I-73 South 2010 NEPA

INTERSTATE 73 SOUTH DILLON, HORRY, AND MARION COUNTIES, SOUTH CAROLINA

Final Environmental Impact Statement Re-evaluation

Figure 2-1: I-73/I-95 Interchange Ramp Widening

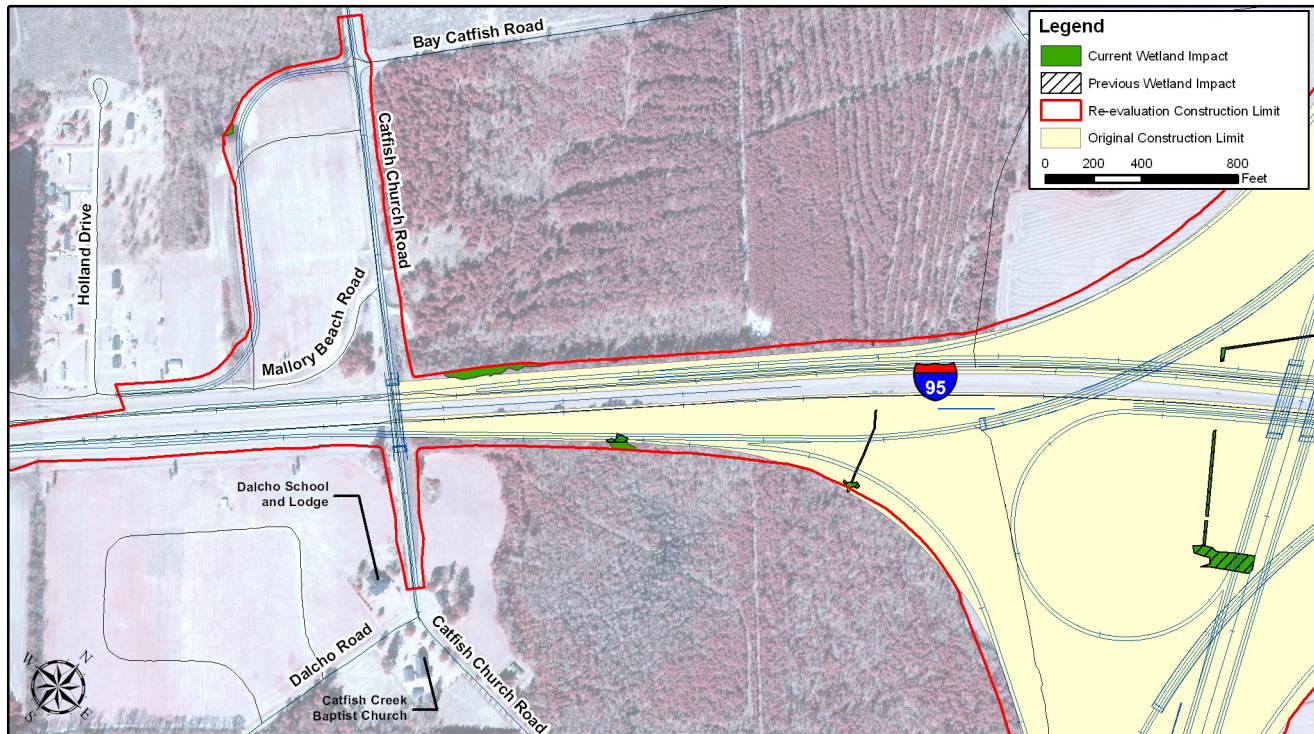
Initially, the flyover ramps connecting I-95 northbound to I-73 northbound and I-95 southbound to I-73 southbound were proposed to have one 16-foot lane (refer to Figure 2-1, page 11). (This design change is also referred to as the Catfish Church Road shift, refer to Appendix B). The VE Study Team stated that the future traffic projections may have poor levels of service (LOS) in twenty-five to thirty years based on the design hour volumes, and recommended that these two flyover ramps have two 12-foot lanes instead, to accommodate the future traffic. LOS is a scale to describe the operational conditions within a traffic stream, with LOS A representing the best operational conditions, and LOS F representing the worst.¹⁵ In support of this proposed design change, a traffic study was completed to provide a LOS comparison between the one 16-foot lane, and two 12-foot lanes.¹⁶ Based on peak hour

traffic operational analysis for the design year of 2035, the flyover ramp connecting I-95 northbound to I-73 northbound would operate at a LOS D, and be at capacity eighty percent of the time (refer to Table 2.1). In addition, based on the average annual traffic growth rate of 1.24 percent, traffic would exceed capacity on the flyover ramp by 2053, before the 75-year *useful life* of the flyover ramp has been reached.

future traffic projections and ensure an acceptable LOS. While the I-95 southbound to I-73 southbound flyover would have acceptable LOS with either the one 16-foot lane or two 12-foot lanes, it was recommended that the two 12-foot lanes be constructed to provide several advantages.

To implement the proposed design change, the interchange footprint would be extended by approximately 3,300 feet south along the edges of I-95 to accommodate the additional lane on each side of the mainline of I-95 for the flyover ramps (refer to Figure 2-1, page 11). These lanes would be acceleration/merge lanes needed for the flyover ramps. The overpass bridge on Catfish Church Road (Road S-17-63) would need to be extended beyond the original design length to allow the additional lane width on I-95. Mallory Beach Road, which connects from Catfish Church Road to Holland Drive, would have to be relocated to maintain access to Catfish Church Road for residences.

Figure 2-2: I-73/S.C. Route 22 Interchange Ramp Re-design

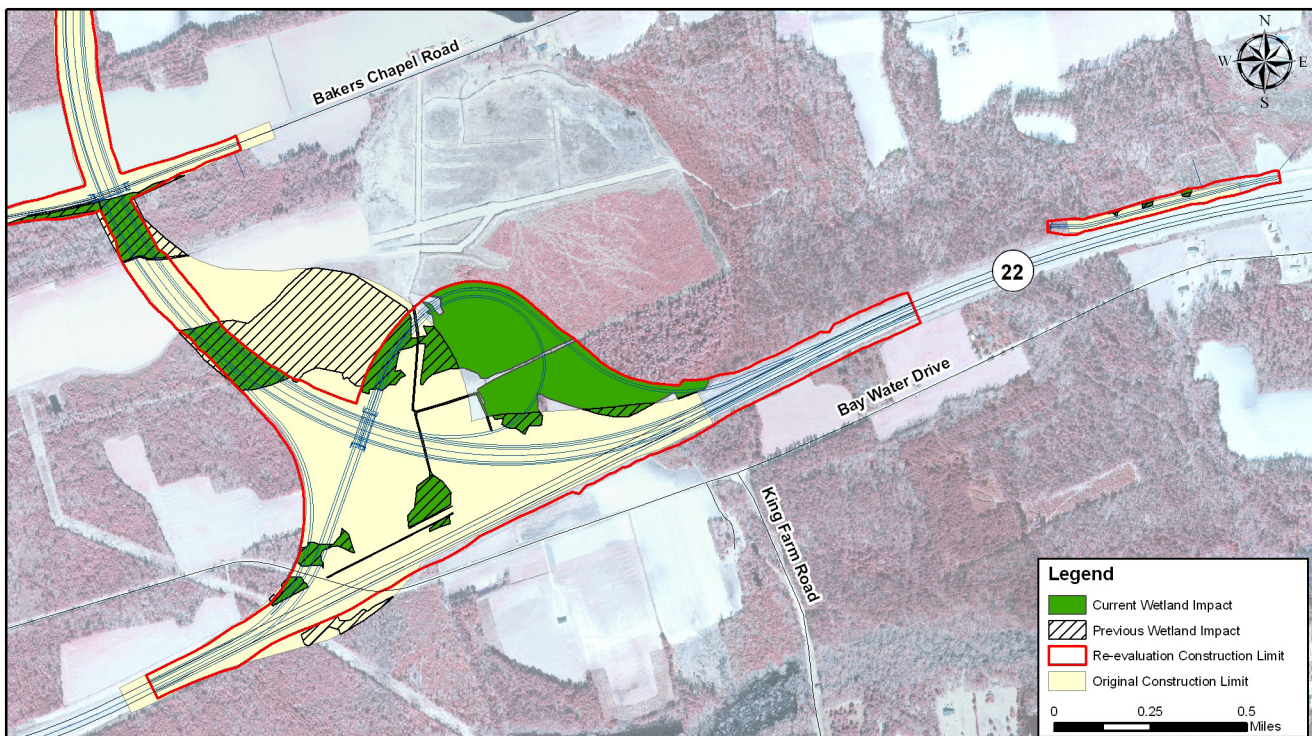
The original interchange ramp design connecting I-73 South to S.C. Route 22 was a three-level, system-to-system directional interchange, with multiple bridges. To reduce costs, the VE Study Team recommended that the interchange be changed to a two-lane trumpet design (refer to Figure 2-2, page 13). This would result in a two-level design.

The advantages of the proposed design change would be an estimated cost savings of \$31.1 million by reducing the number of bridges. In addition, it would lessen the impact to Bakers Chapel Road (S-26-97), since the acceleration lane from the ramp onto I-73 northbound would be tapered down before reaching the Bakers Chapel Road overpass. This would result in a smaller overpass footprint at Bakers Chapel Road.

To implement the proposed design change, the interchange ramp would be expanded by approximately 1,000 feet to the east (refer to Figure 2-2, page 13). The ramp connecting S.C. Route 22 eastbound to I-73 northbound would be a loop ramp. Through traffic in the S.C. Route 22 westbound lane would follow a semi-loop around the northern edge of this loop ramp, and would continue westbound (refer to Figure 2-2). Traffic from S.C. Route 22 westbound would make a continuous movement to I-73 northbound. An acceleration/merge lane would be provided on I-73 northbound, but taper to two lanes prior to the Bakers Chapel Road overpass. This would shorten the bridge overpass length at Bakers Chapel Road, and require less fill embankment on either side of the overpass. Vehicles from I-73 southbound would make a continuous movement and merge from the left onto S.C. Route 22 eastbound. A ramp from I-73 southbound would accommodate traffic heading west onto S.C. Route 22.

Figure 2-3: Barnhill Road Overpass Re-alignment

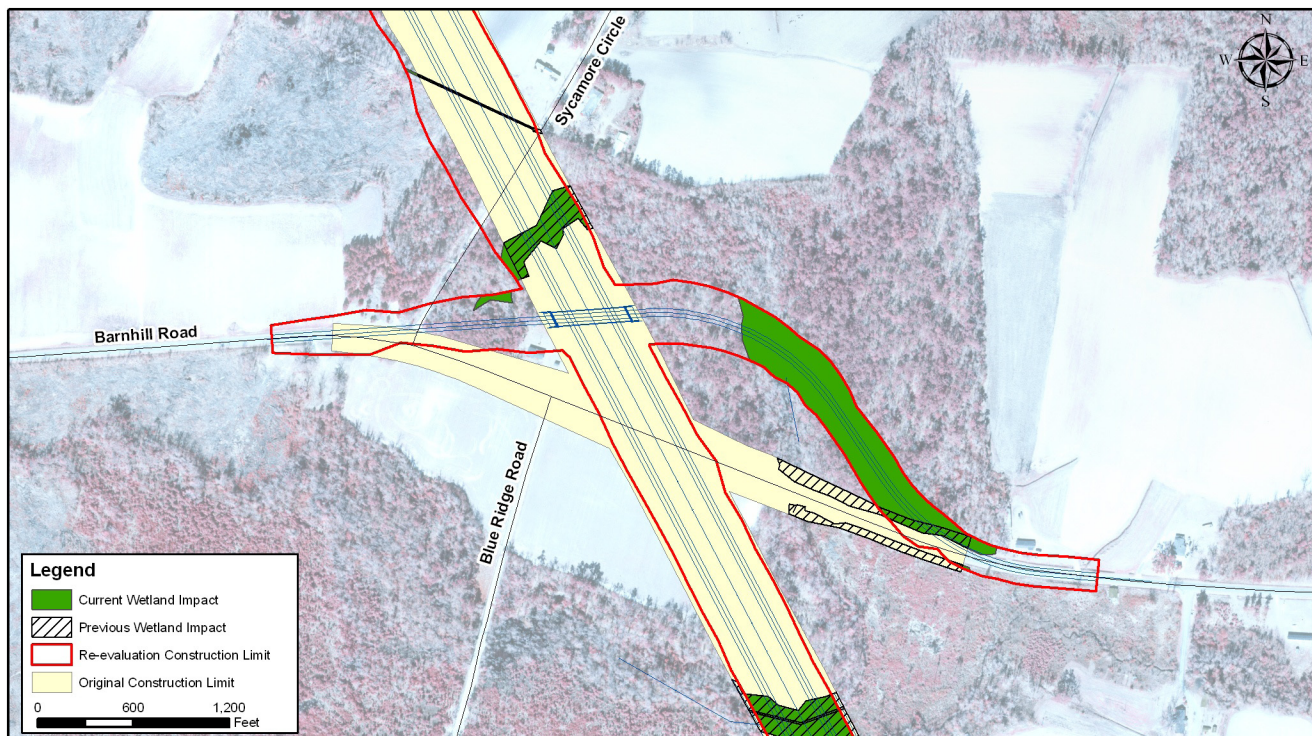
Whenever a road crosses over another road at an angle greater than 90°, this is termed as a skewed crossing. The greater the variance from 90° the “heavier” the skew, and the longer the bridge length needed to cross over. The original overpass designed at Barnhill Road as part of the Selected Alternative crossed at a sharp angle, or “heavy” skew, which would result in longer span lengths which would dictate use of continuous structural steel superstructures (refer to Figure 2-3, page 14). Continuous structural steel superstructures are required on bridge spans that are greater than 140 feet in length, and are more costly when compared to pre-stressed concrete girders that could be used for bridge spans 140 feet or less. In addition, the “heavy” skew can result in less predictable behavior of the bridge during a seismic event. To reduce costs and the “heavy” skew, the VE Study Team recommended that the bridge be shortened and the skew be reduced so that pre-stressed concrete girders could be used.

The proposed design change would have an estimated cost savings of \$1.1 million, and pre-stressed concrete girders would require less maintenance costs. In addition, the skew would be improved, which would result in more predictable behavior should a seismic event occur in the area.

Barnhill Road would be re-aligned to the north, with the overpass bridge approximately 400 feet north of the existing Barnhill Road (refer to Figure 2-3). The bridge would be straightened to reduce the skew, and be reduced by 4,286 square feet.

Figure 2-5: Good Luck Road Re-alignment

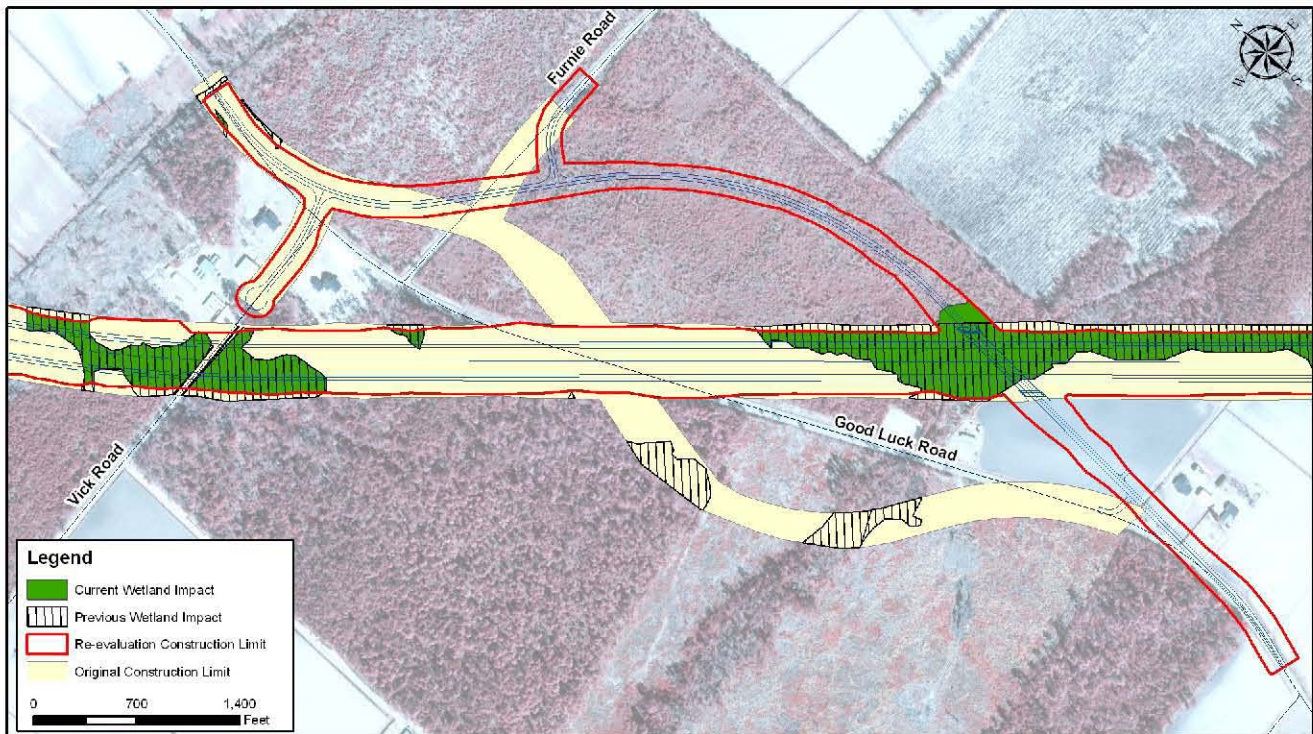
The original design of Good Luck Road involved two curves, on either side of the overpass bridge (refer to Figure 2-5, page 16). To improve the design and driver expectancy on Good Luck Road, the Design Team proposed a re-alignment east of the original alignment by approximately 650 feet at its farthest point, and cross the interstate approximately 1,450 feet south of where the original alignment crossed (refer to Figure 2-5, page 16).

Figure 2-6: J.H. Martin Road at Joiner Swamp Road Frontage Road Re-alignment

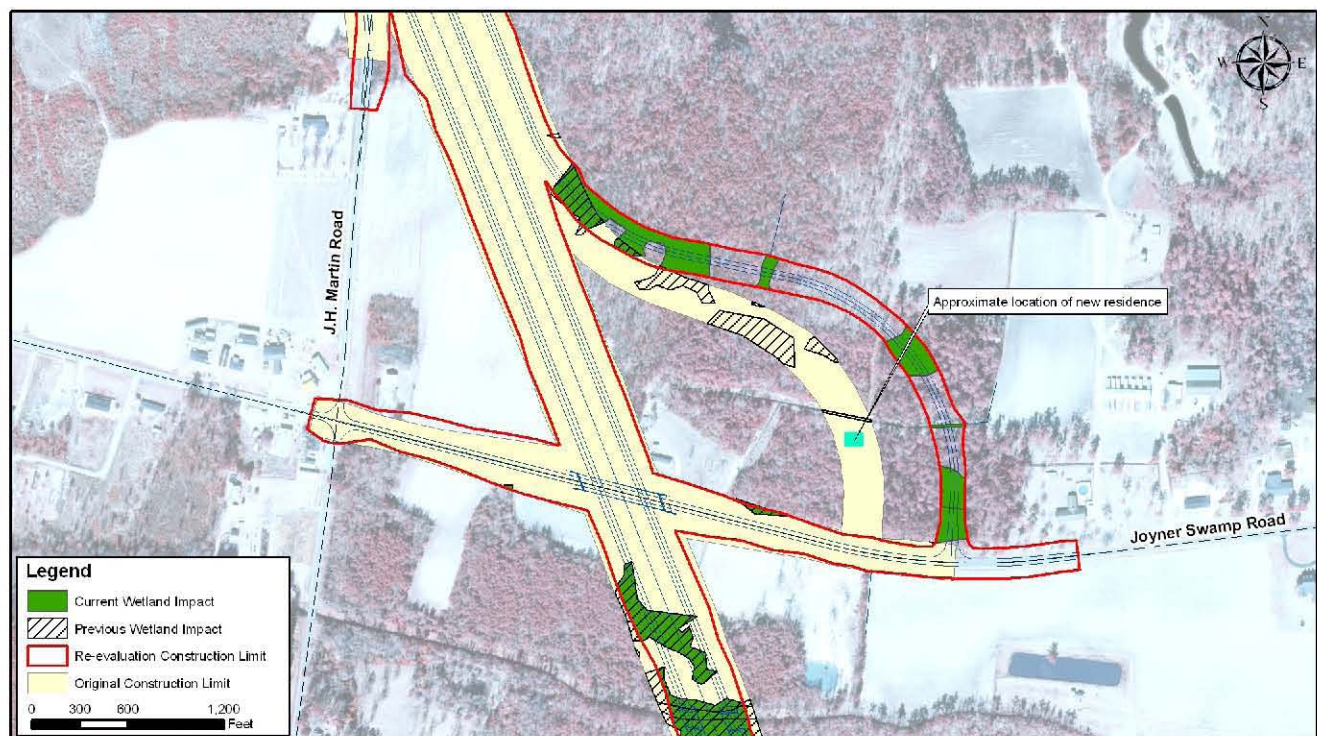
Originally, the frontage road for J.H. Martin Road at Joiner Swamp Road was located approximately 750 feet east of the centerline of I-73 South (refer to Figure 2-6, page 2-16). Recently, a new house was constructed in the construction footprint of the frontage road. To avoid relocating the residence, the Design Team proposed shifting the frontage road by approximately 300 feet east of the original alignment.

One-Lane Trumpet Interchange
VE Proposed Option

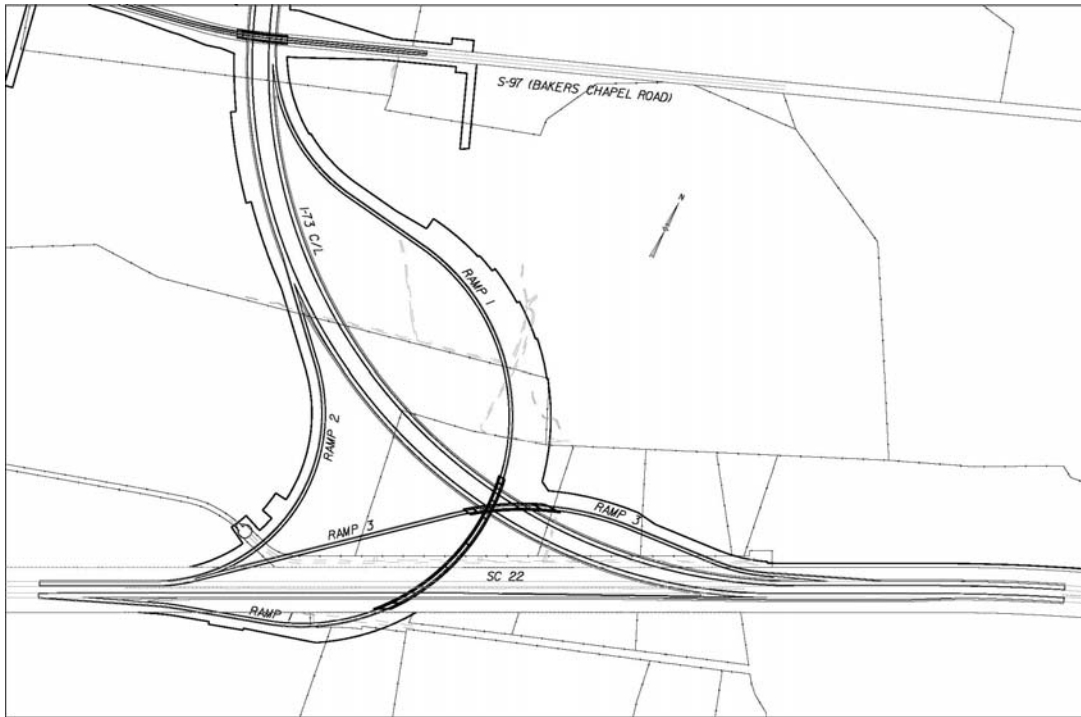
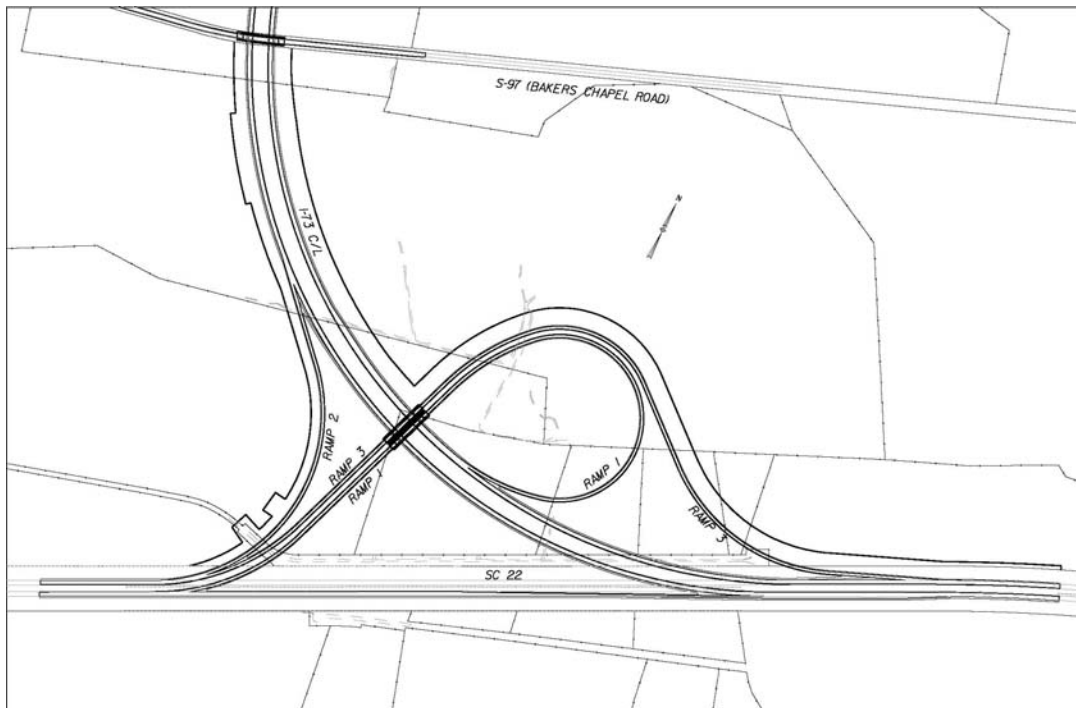
Pros	Cons
Reduce ramp fill heights and bridge requirements for a cost savings estimated at \$31.1 Million	Safety issues with loop design
Lessen length of Bakers Chapel Road crossing bridge (end acceleration lane prior to crossing under the Bakers Chapel Road bridge)	Two of the four ramps will have reduced (60-40-60 mph) design speeds. Directional ramps are all at 55 mph
No conflict with hurricane evacuation	May require reopening the EIS to assess impacts
Handle estimated volumes at design year (with projected SELL project volumes)

PROPOSED VE ALIGNMENT

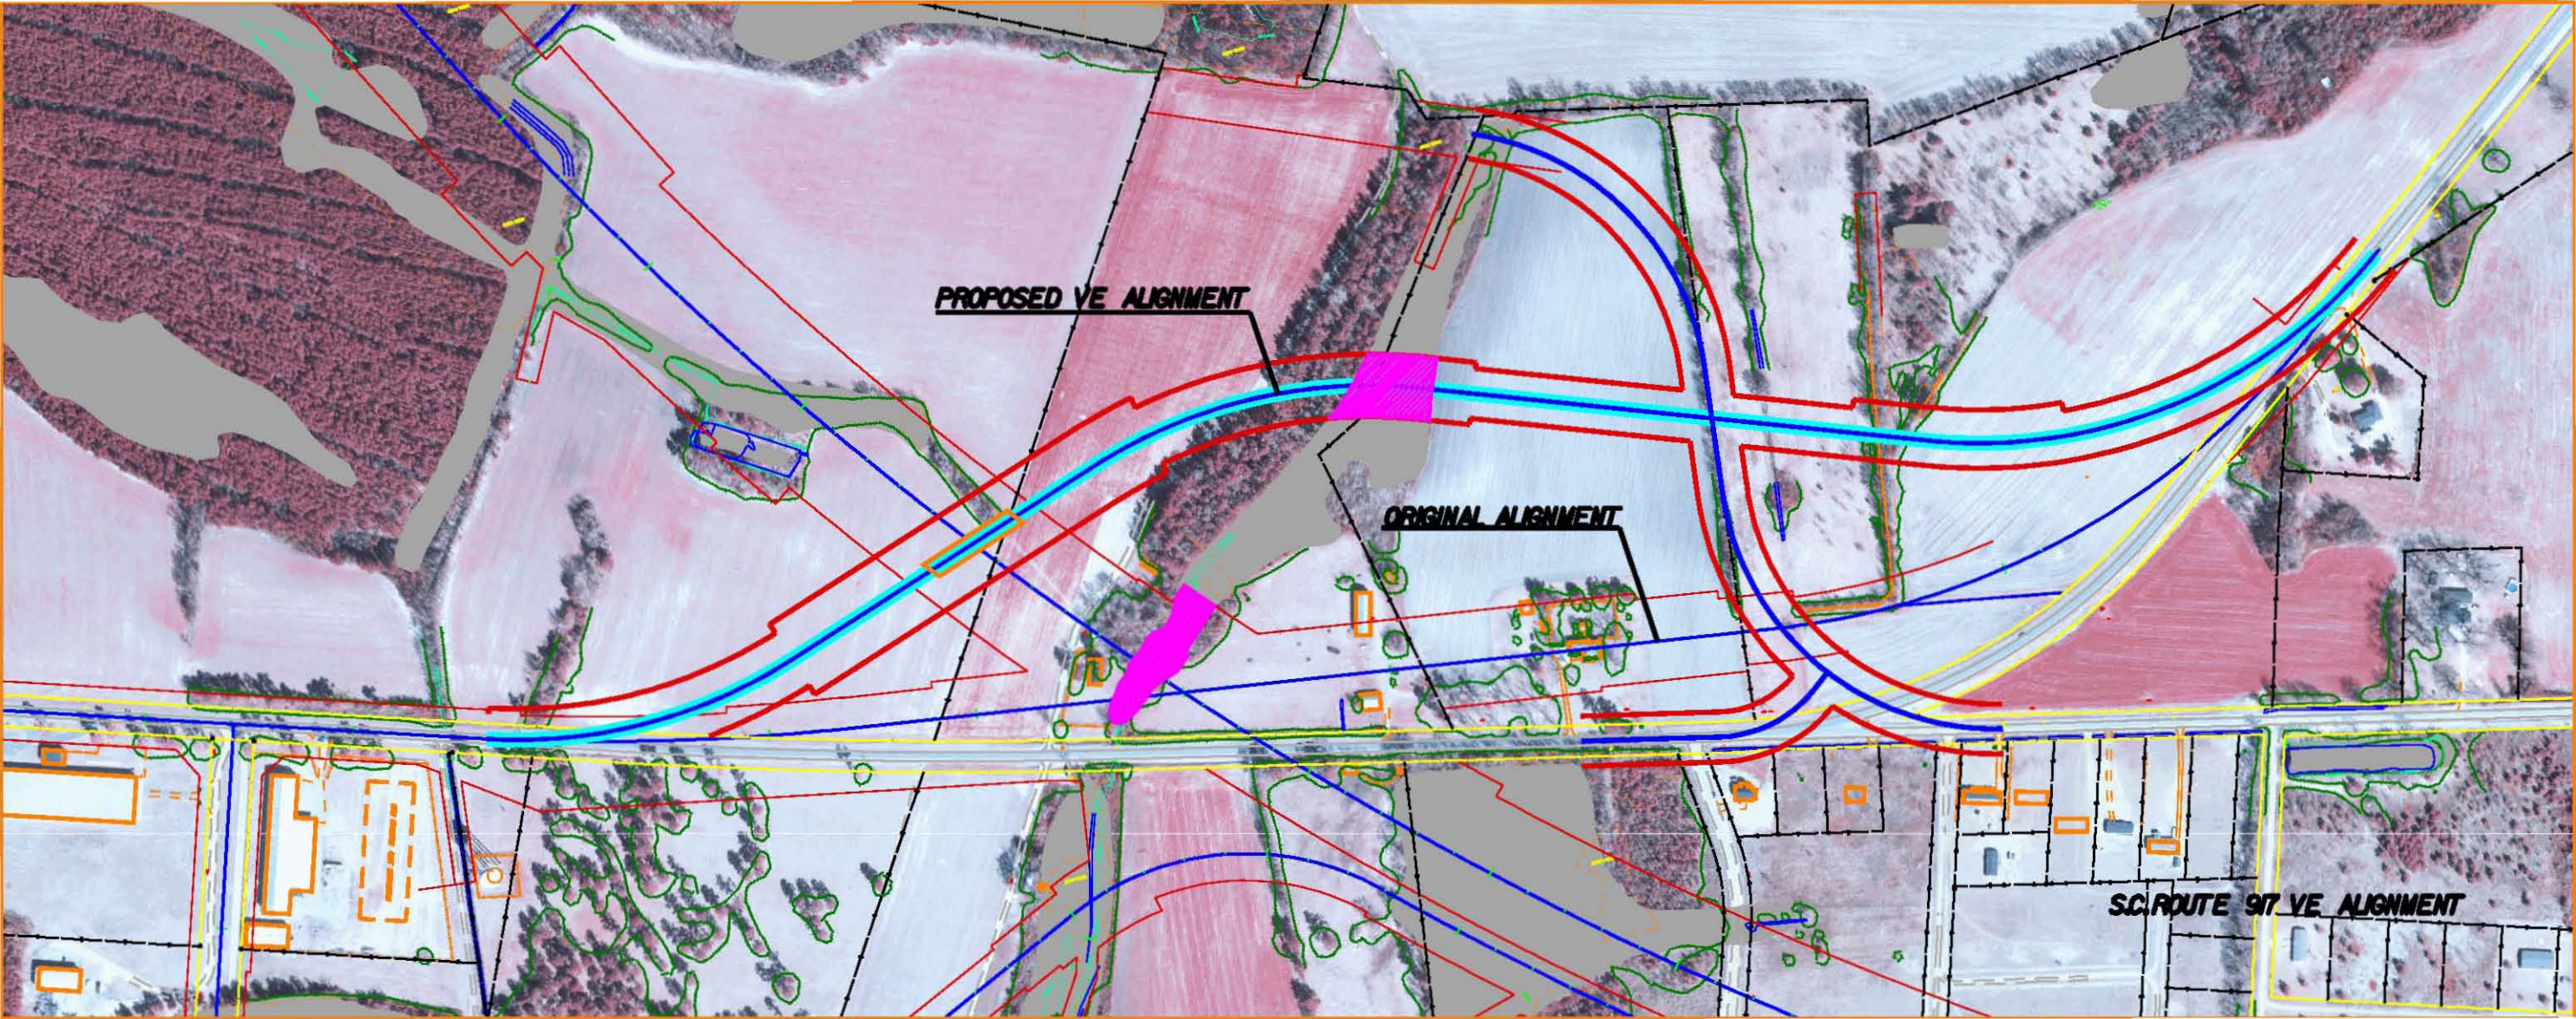
Reconfigure the bridge to reduce the heavy skew.

Pros	Cons
Cost savings of \$1.6 Million in bridge construction	Would require reopening the EIS document to assess the impacts
Avoid displacement	Less desirable roadway alignment
Significantly reduce skew	Multiple horizontal curves introduced on SC197
Concrete girders require less maintenance than steel girders	Anything changed at this point will be controversial with the community
More predictable seismic behavior	Increased wetland impact of 0.7 acres.
